INDESIT company

Model type:
AVXXF129EX

Commercial code:
F033727

n4008c02: Rear drum replacement

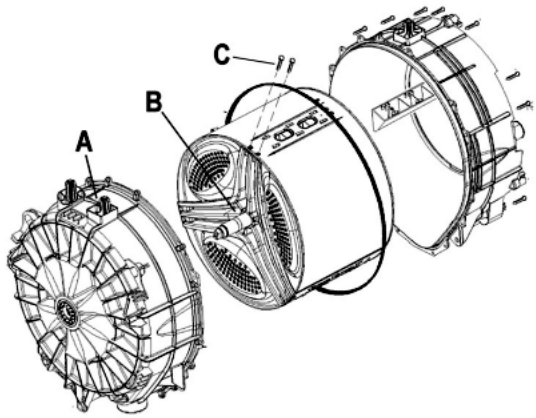
All drum service replacements use 35mm bearings

When you use in assistance the rear drum you will also need to change the drum bearing spider from the 30mm version to the 35mm version

A = C00119357 Drum Rear
B = C00117329 Drum Bearing Spider
C = C00201310 Drum Bearing Spider screws (Qty 6)

Production use 3 screws but for Service we suggest that 6 screws are used.

n0508c01: Door Gasket Clamp Band

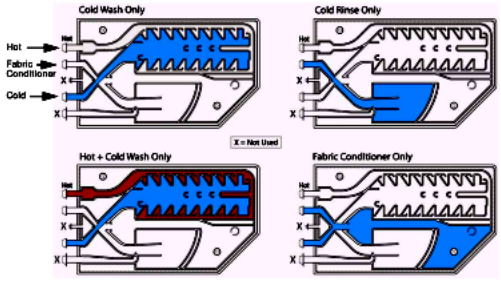
A New Polypropylene Gasket clamp band has been introduced in production from Serial number 80325.0000
The purpose is to provide added support to the inner rim of the door gasket.
